Goose Creek Overlook

ZMAP-2020-0005, ZCPA-2020-0008,
ZMOD-2020-0020 , ZMOD-2020-0026

Board of Supervisors Business Meeting
March 2, 2021

Discussion (1 of 3) – Civic Space

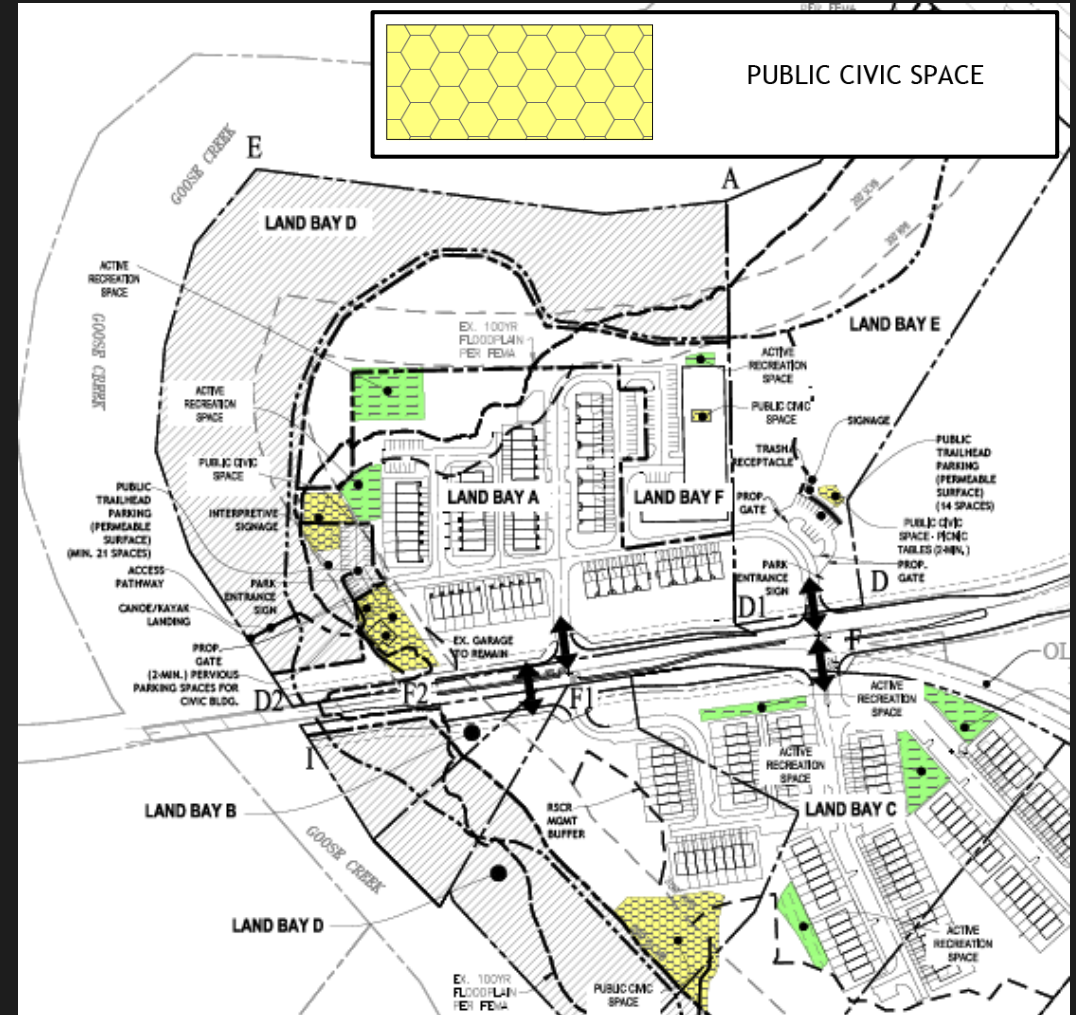
1. Civic Uses – Suburban Neighborhoods expected to provide 10% of developed area for civic use (approx. 3.85 acres).
2. Active Recreation in Floodplain – Active recreation uses are not supported within Major Floodplain.
3. Improvements proposed in 300-foot No-Build Buffer – Ground disturbance within 300 feet of Goose Creek is not supported.

Currently Proposed : (0.67 ac)

- 1,000 SF multipurpose room
- 2,275 SF Hennessy Garage
- 26,000 SF Southern Overlook
- Other labels on CDP

Dedicate 10% of development (3.85 ac) as civic use, clarify programming, & provide acreage.

Discussion (2 of 3) – Active Rec. in Floodplain

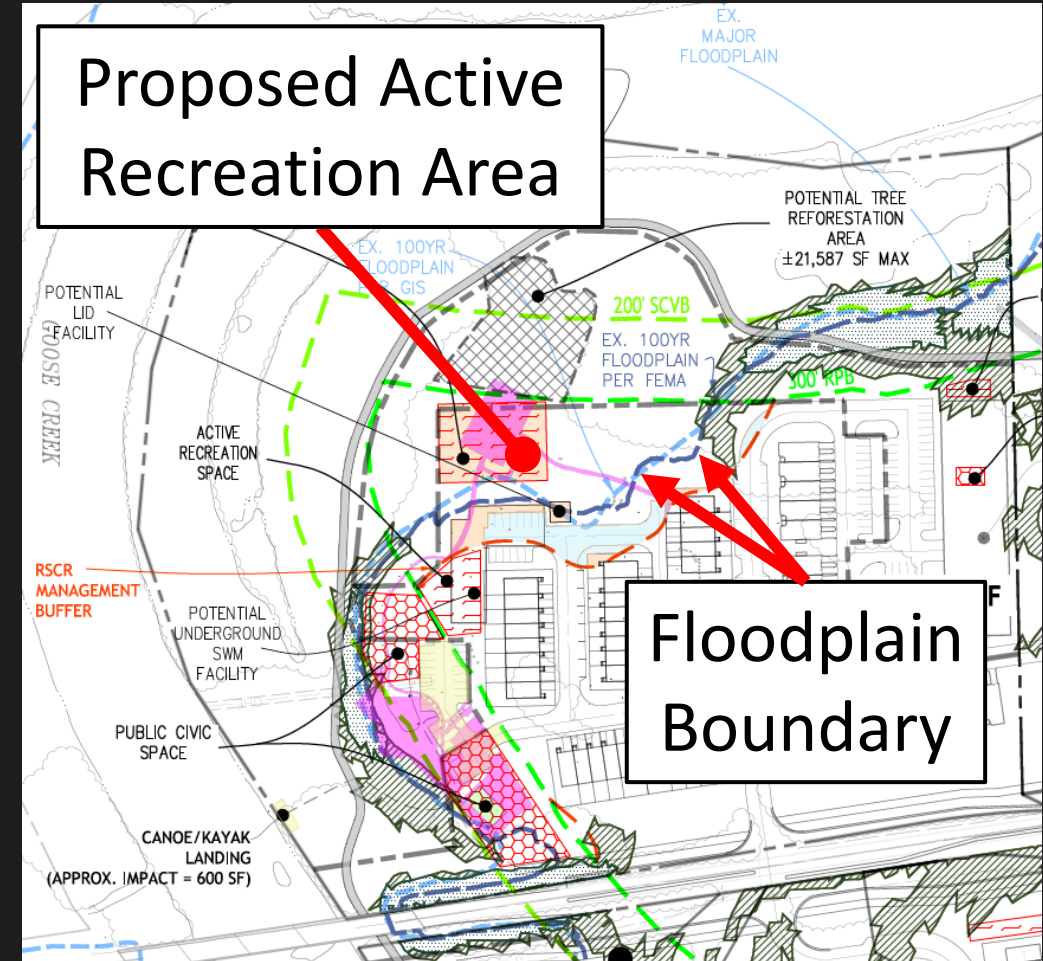
Modified list of active recreation uses proposed in Major Floodplain

Provide the ZO required active recreation areas outside of Major Floodplain per 2019 GP

Discussion (3 of 3) – Improvements in “No-Build”

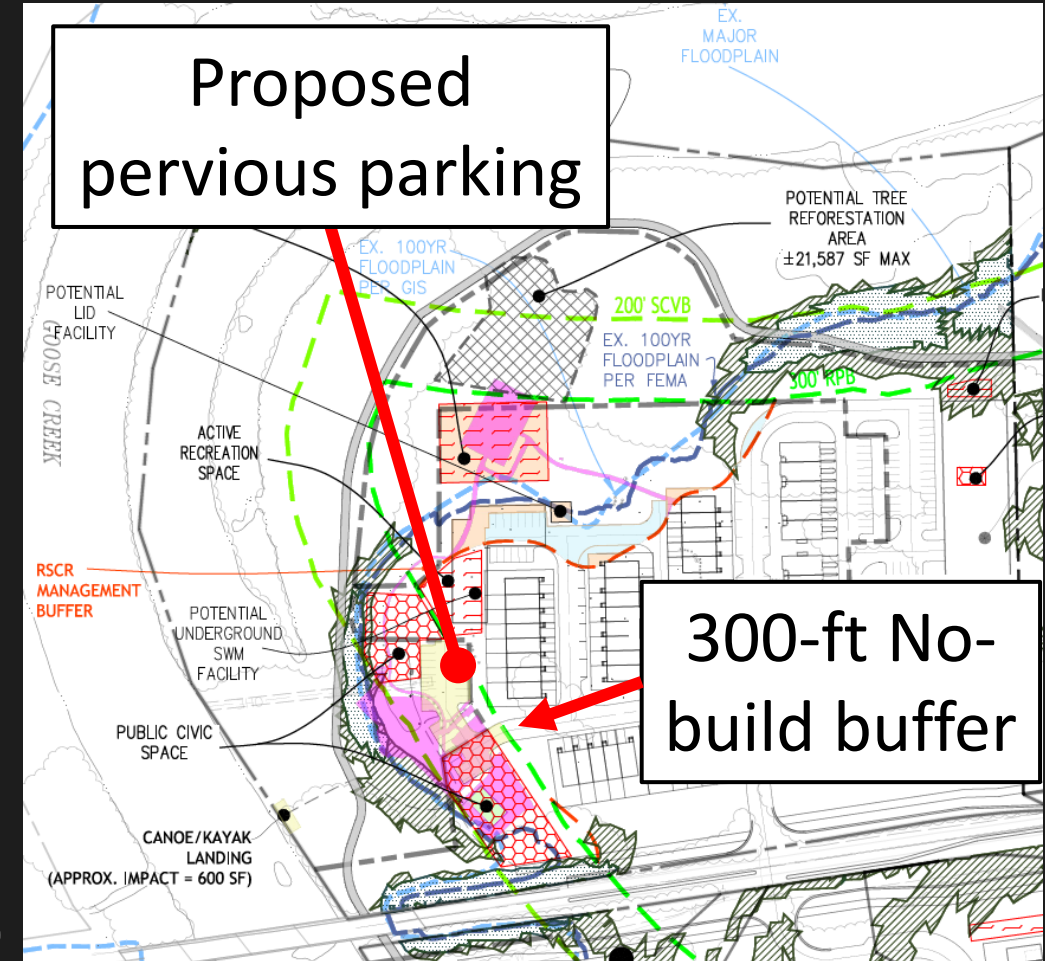
- Pervious parking (8,735 SF)
- Kayak launch (600 SF)
- Remove existing impervious area (24,773 SF from no-build & RSCR)

Consider appropriateness of proposed improvements w/in 300-foot No-Build buffer
